Product End-of-Life Notification

EOL Number: RE092901

The AT73C213, AT73C213B will be discontinued.

FROM AT73C213 TO AT73C240

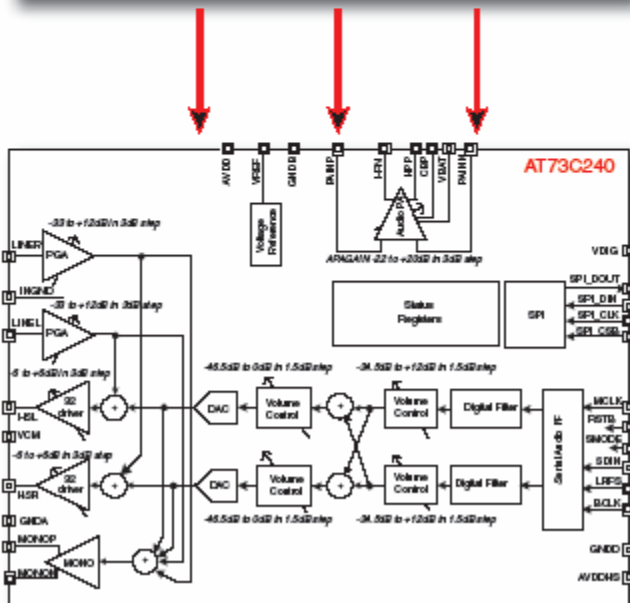
Differences between AT73C213B and AT73C240:

- Remove of the Low Power Mode of the Audio Power Amplifier.
- Remove of the Auxiliary Input
- Modification of the mapping registers.
- The package is reduced by 22% to a 5*5mm QFN32 package.

Pad allocation is exactly the same

For customer using AT73C213B software, please read the application note doc6484A, to update software for AT73C240
